Ortega and Santa Catalina Dinning Commons
Boiler Replacement, Bldgs. 542 & 860
Project No. FM120316S/137-53/139-52
Addendum No. 4

ADDENDUM NO. 4

SINGLE LINE DIAGRAM

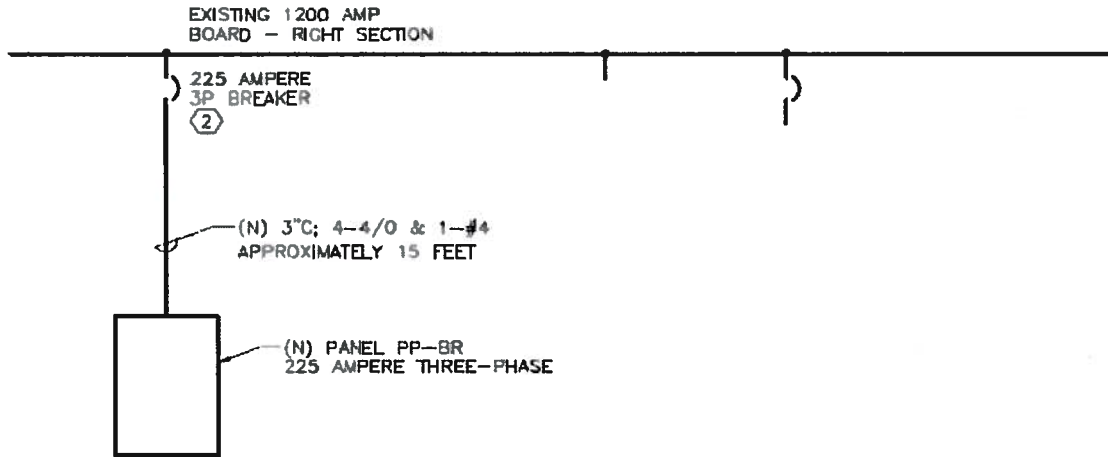
- 3-1. Drawing No. E-001: Replace single line diagram on E-001 with single line
diagram shown below.

- ② CONTRACTOR TO INSTALL (N) GENERAL ELECTRIC K FRAME BREAKER
